SERVICE BULLETIN

Subject: **Accessory Port Power Supply Issue - Possible Inverted Wires at Vehicle Connector**

No. **2020-7**

REVISION 1
April, 2021

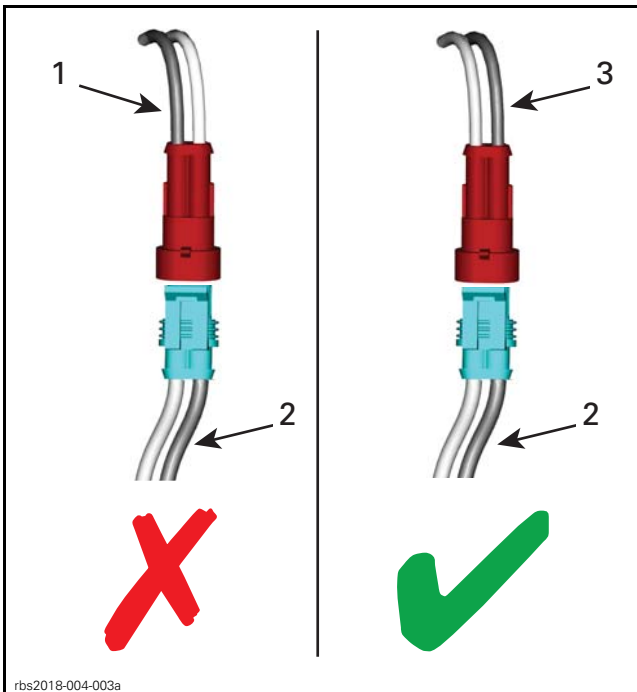
Vehicles equipped with GPS kit may experience inner battery charging issues. One of the probable cause is inverted wires at vehicle connector

2. Make sure the black wire on the male connector is on the same side as the female connector.

1. Black wire on female connector at the wrong location
2. Black wire on male connector
3. Black wire on female connector at the appropriate location
